ENGINEER'S SEAL	HAMPTON INN ® SUNPORT GRADING AND DRAINAGE PLAN	DRAWN BY WCWJ
		DATE 3-19-13
		21226-LAYOUT-7-05-12
DAVID SOULE P.E. #14522	 <i>Rio Grande Engineering</i> 1606 CENTRAL AVENUE SE SUITE 201 ALBUQUERQUE, NM 87108 (505) 872-0999	SHEET # — 21226

Grading and Drainage Plan /
Grading Details

TITLE: **HAMPTON INN • SUNPORT
WALL EXHIBIT**

ENGINEER'S SEAL  DAVID SOULE P.E. #14522	HAMPTON INN @ SUNPORT GRADING AND DRAINAGE PLAN  <i>Rio Grande Engineering</i> 1806 CENTRAL AVENUE SE SUITE 201 ALBUQUERQUE, NM 87106 (505) 872-0999	DRAWN BY WCUJ
		DATE 2-04-13
		21226-LAYOUT-7-05-12
		SHEET # —
JOB # 21226

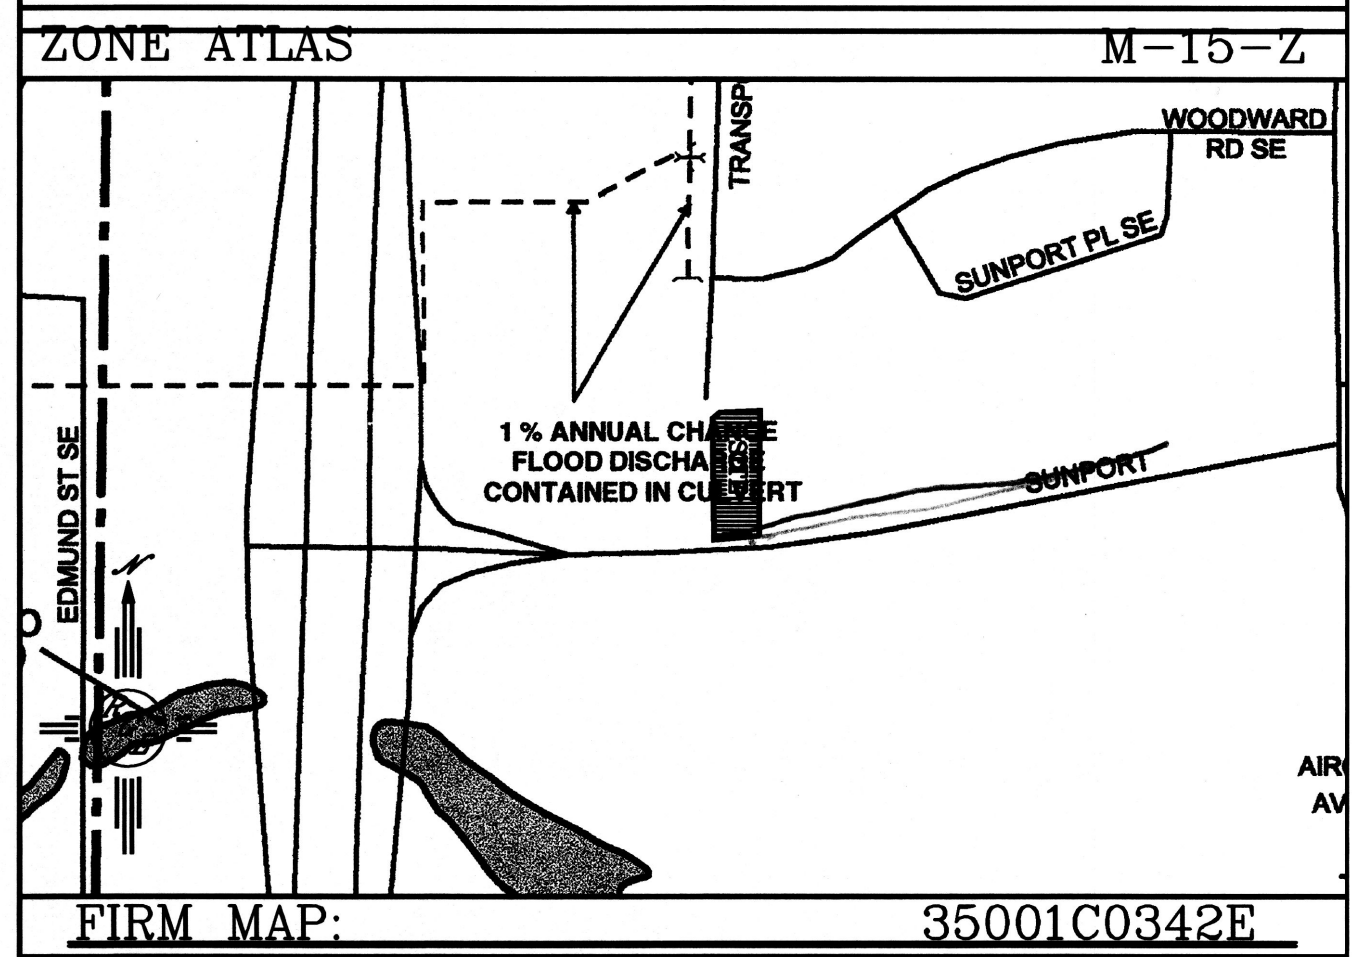
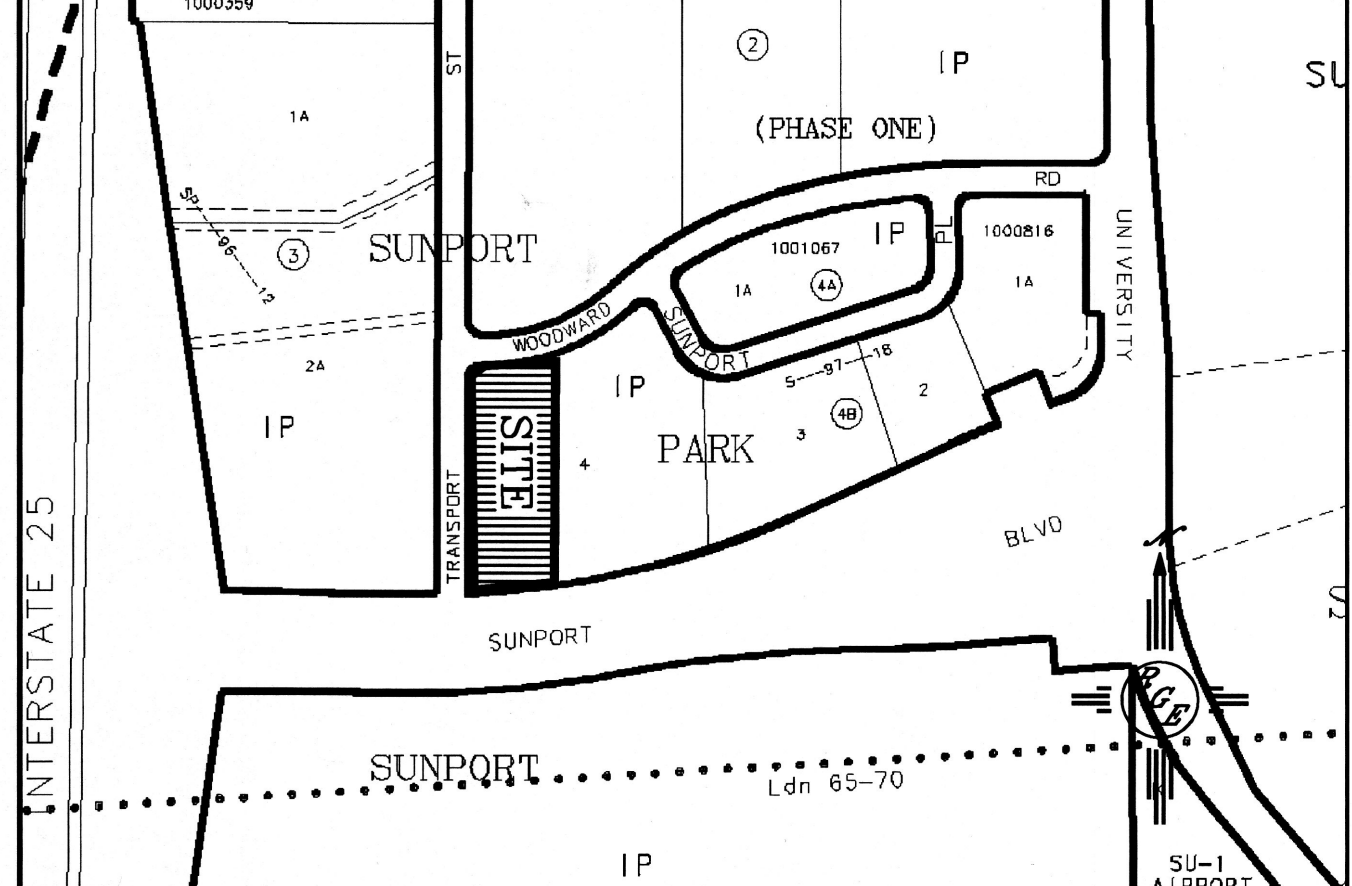
- 1- Show contours on dashed
- 2- Arching makes it hard to read the #s
- 3- Provide additional spot elev. on the E side of Bldg.
- 4- Provide spot elev. on the back of sidewalk
- 5- Show roof flow direction
- 6- Provide spot elev. for the into air SDW & are used ADA requirements
- 7- Show all the door locations w/spot elev.
- 8- Show Brown Boulders
- 9- Two FF Elev.
- 10- Show finish contours
- 11- Show det. wall along sidewalk
- 12- Provide section
- 13- Make det. wall elev. for all the prop. wall.

SECTION B-B
NTS

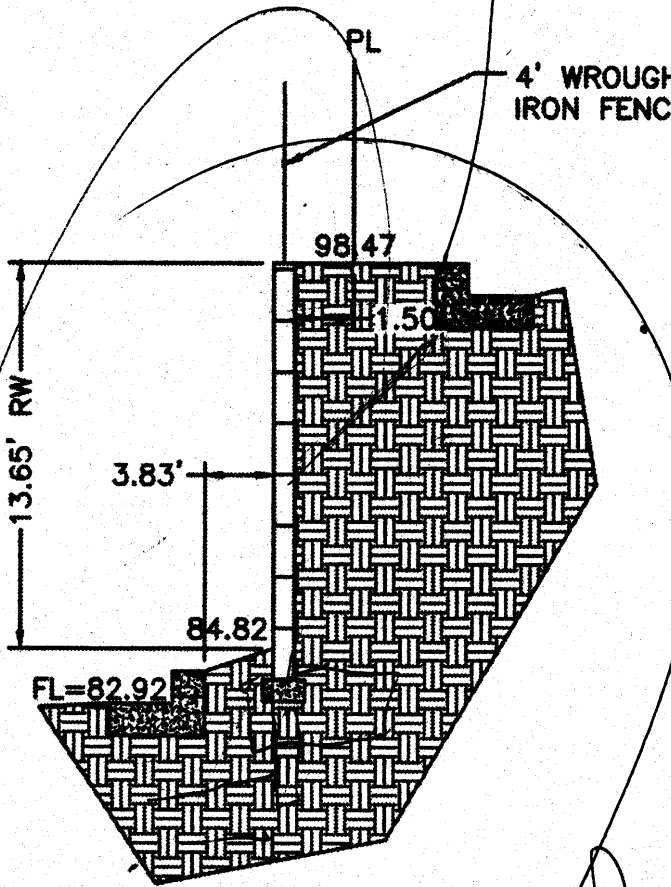
*Need Erosion
Beyond A*

CONCRETE ALLEY GUTTER DETAIL
NTS

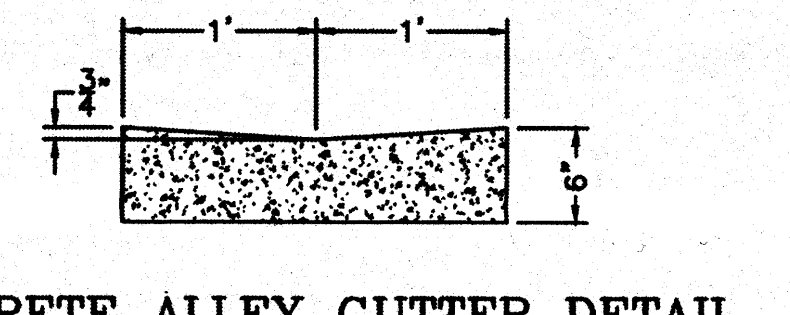
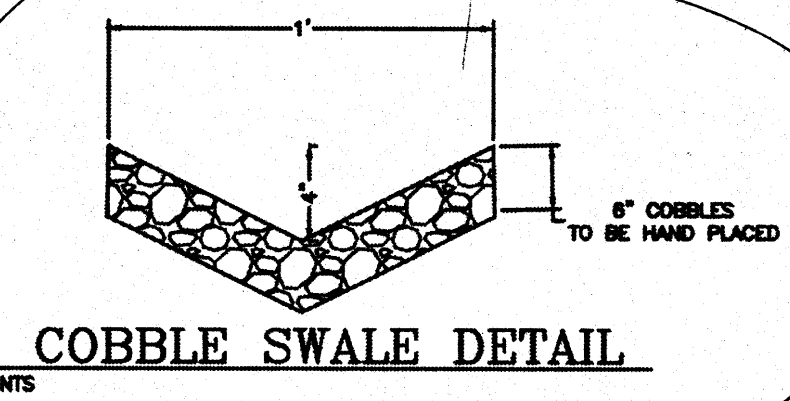
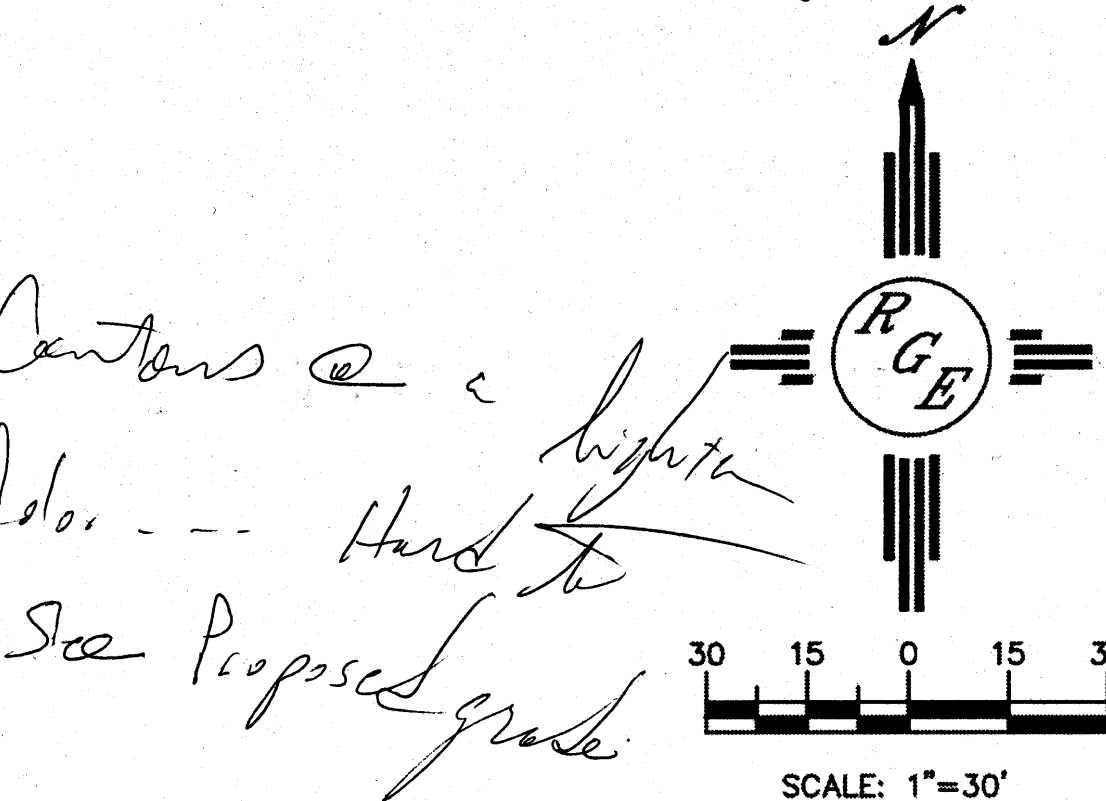
*Truck Endorsement
Restaurant??*

*Provide TW & BW
Slo.*

*Bar Line
To the Church*
